UNITED STATES PATENT AND TRADEMARK OFFICE

APPLICATION NO.	FILING DATE	FIRST NAMED INVENTOR	ATTORNEY DOCKET NO.	CONFIRMATION NO.
10/760,448	01/20/2004	Don Alan Gilliland	ROC920030364US1	9231
30206	7590	10/06/2004	EXAMINER	
IBM CORPORATION				THOMAS, ERIC W
ROCHESTER IP LAW DEPT. 917				ART UNIT
3605 HIGHWAY 52 NORTH				PAPER NUMBER
ROCHESTER, MN 55901-7829				2831

Office Action Summary	Application No.	Applicant(s)
	10/760,448	GILLILAND ET AL.
	Examiner Eric W Thomas	Art Unit 2831

DETAILED ACTION

302

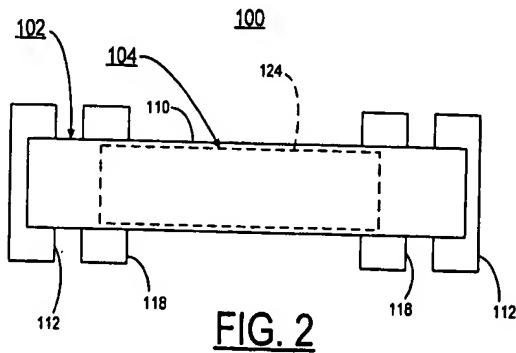
2. The drawings are objected to because reference number 302 is not referencing anything.

Corrected drawing sheets in compliance with 37 CFR 1.121(d) are required in reply to the Office action to avoid abandonment of the application. Any amended replacement drawing sheet should include all of the figures appearing on the immediate prior version of the sheet, even if only one figure is being amended. The figure or figure number of an amended drawing should not be labeled as "amended." If a drawing figure is to be canceled, the appropriate figure must be removed from the replacement sheet, and where necessary, the remaining figures must be renumbered and appropriate changes made to the brief description of the several views of the drawings for consistency.
